2121 M Street, NW

Board of Zoning Adjustment
RENAISSANCE
CÉNTRO

**GOVERNMENT OF THE DISTRICT OF COLUMBIA
DEPARTMENT OF CONSUMER AND REGULATORY AFFAIRS
OFFICE OF THE ZONING ADMINISTRATOR**

From: Avitabile, David
Sent: Sunday, November 10, 2013 12:32 PM
To: 'Ndaw, Mamadou (DCRA)'
Cc: 'LeGrant, Matt (DCRA)'; Epting, John; 'Ilan Scharfstein'
Subject: 2121 M Street (B1310607) - Response to Zoning Review Comments
Attachments: RE: 2121 M Street -- Review of our discussion; 2121 M Street -- Review of our discussion; Determination Ltr re 2109 M St to Epting 12-6-2010.pdf; At-Grade Connections.pdf; Valet Parking Plan.pdf; Hyatt Place M Street Rooftop Structures .pdf; Hyatt Place M St Site Plan - loading.pdf

1 ROOF TERRACE PLAN
A111 1/8" = 1'-0"

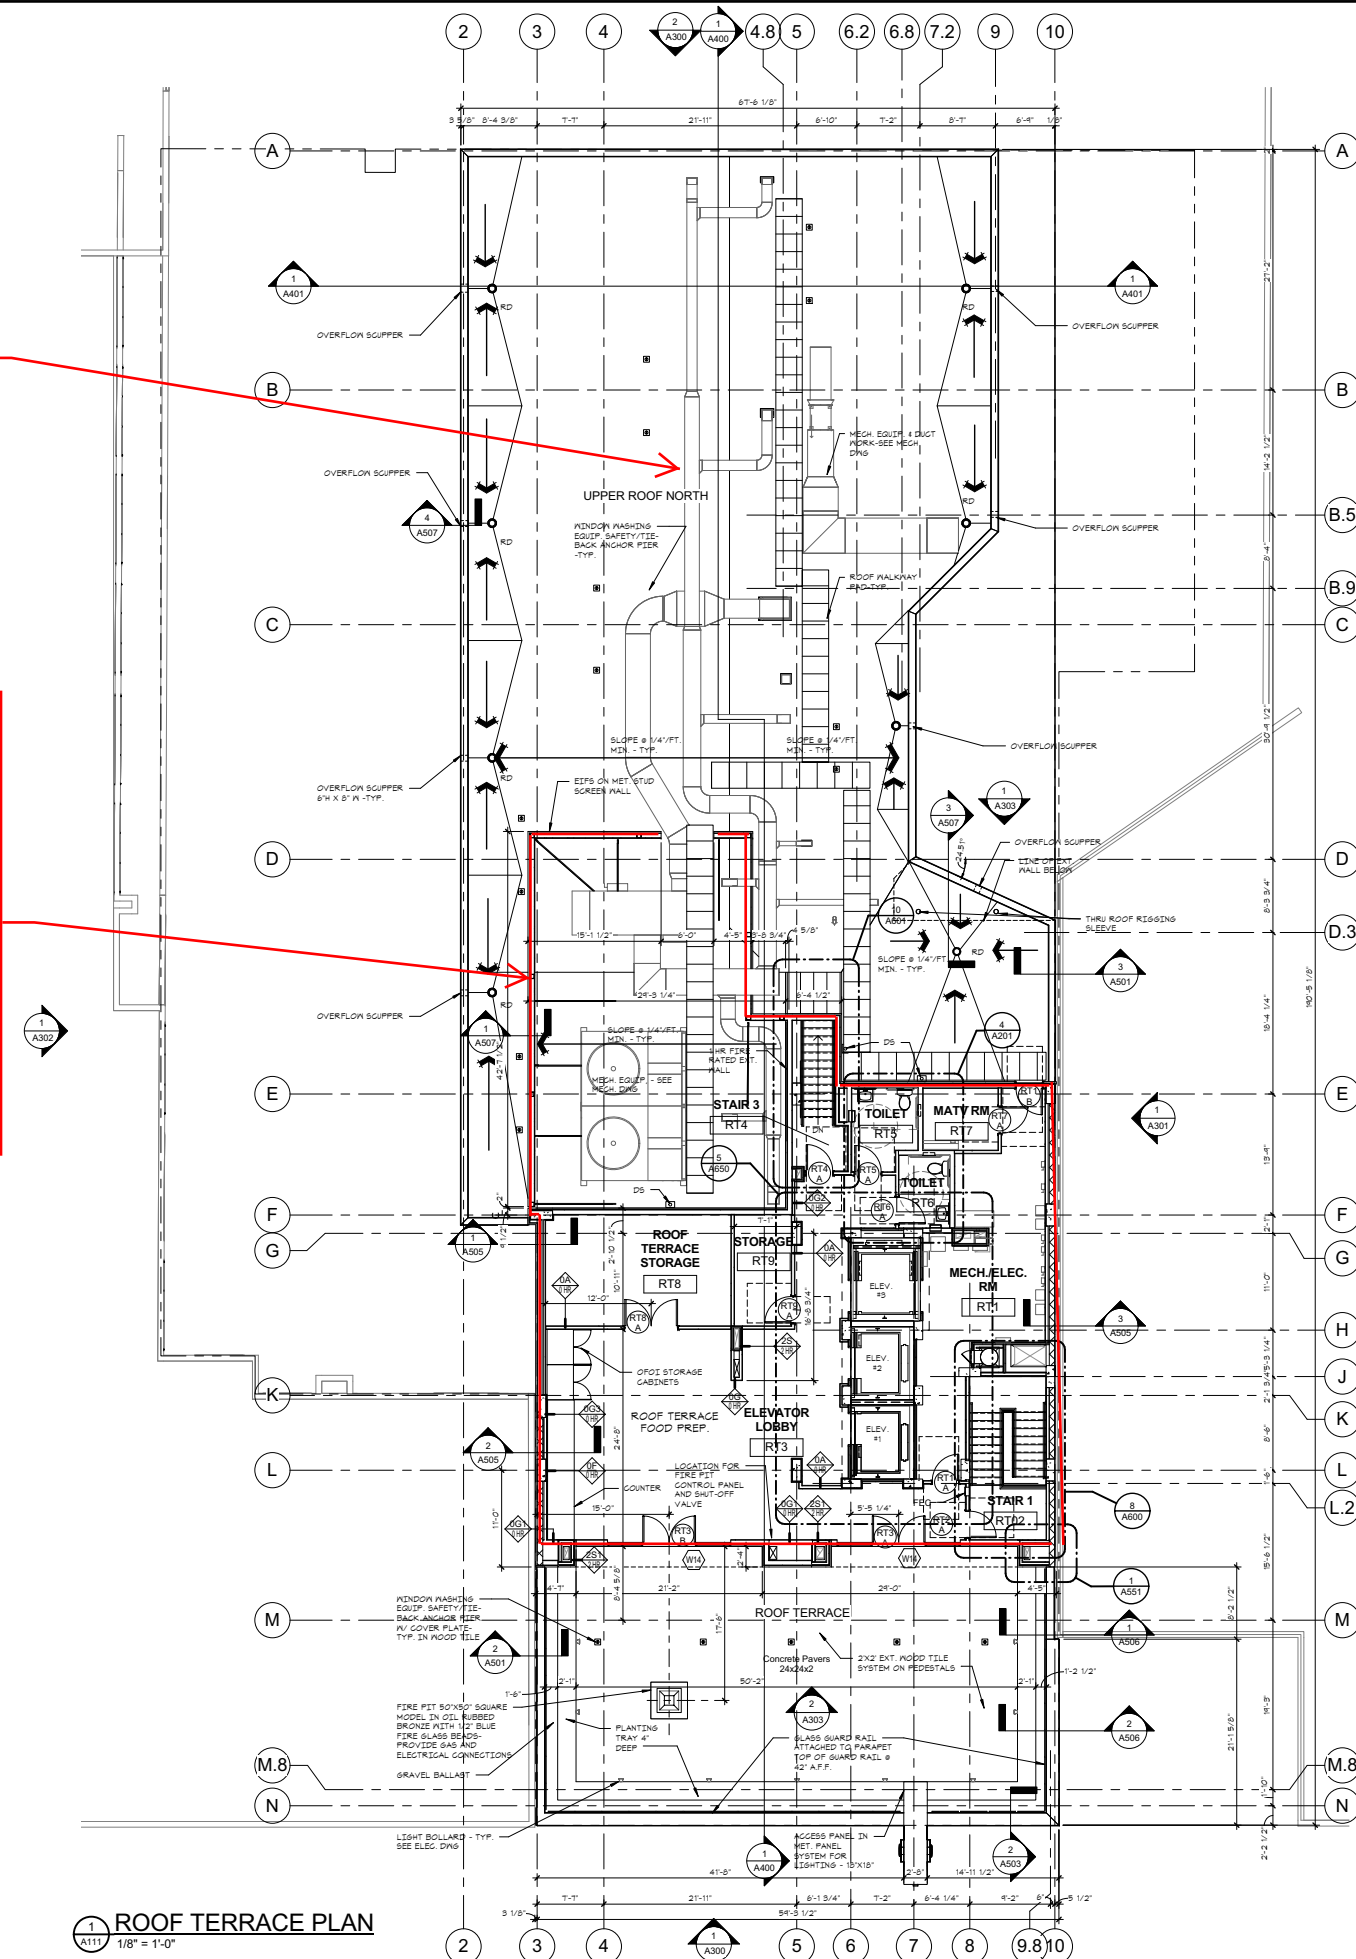
RED LINES
INDICATES
ROOFTOP
STRUCTURE
(SCREEN WALL)
ENCLOSING
MECHANICAL
EQUIPMENT.
MAXIMUM HEIGHT
IS 18'-6" ABOVE
UPPER ROOF
ELEVATION

- As we discussed, the proposed Project contains a roof structure that is set back from all exterior walls (that is, the south wall that faces M Street and the north wall that faces the open court). No setback is required from the east wall, which is a lot line wall that abuts another 90-foot tall building, or from the west wall, which faces a closed court within the single record lot.
- Pursuant to our discussion, we have modified the roof structure to reduce the amount of accessory space within the structure and clarify that the enclosed space is intended to be used for uses that are accessory to the rooftop recreation space , as shown on the attached plan. Please confirm that the revised roof plan is acceptable.

Thanks for the clarification, as well as illustrative plans that were attached to your email. By this email I am confirming my agreement with its analysis, and its conclusion that the areas of the rooftop structure comply with Section 411 of the Zoning Regulations.
